MERCURY	ser	rvice	bu	lletin
WARRANTY INFORMAT PARTS INFORMATION	ION 🗹 SE	RVICE INFORMATIO	ON B	ulletin No. 2002-22 Jet Drive No. 2002-08
Circulate to: Sales Manager	Accounting	Service Manager	🗹 Technicia	n

New Spark Plug (OptiMax)

2.5 and 3.0 Liter OptiMax Outboard 115 Thru 225 HP S/N 0G590000 and Above

Platinum spark plug NGK PZFR5F-11, Mercury P/N 33-855672 1

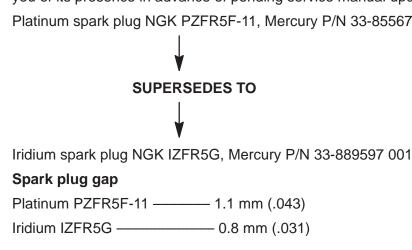
As a 2003 model year running change, OptiMax (not to include Hi-performance OptiMax products) has switched to a new spark plug. The new spark plug has an iridium alloy center electrode that is smaller in diameter and concentrates the spark in one area. The spark gap has also been reduced.

The iridium spark plug will supersede and back fit the platinum spark plug. The platinum and iridium spark plugs can be intermixed and used in the same engine.
